# Access Compliance Report

## Public Rights-of-Way

### (Curb Ramps)

Intersection ID: 7132	Main Street: GRAHAM_MEADOW_DR	Cross Street: HOPE_VALLEY_LN	Location: W
ADA ID: 6A754C17E4D6	Ramp Type: BlendTrans1	Initial Pass/Fail: Fail	Overall Compliance: No
Severity Score: 8.75			
Codes/Mitigation Info/Possible Solution		Field Measurements/Component Compliance

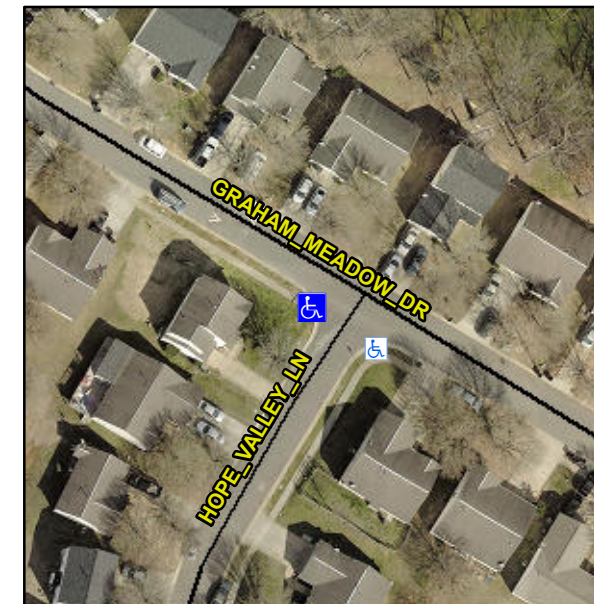
**DAMAGED LNDG**

**Not Found, R304.5.1**

**Remove & Replace Curb Ramp With Two New Directional Ramps or Equivalent.**
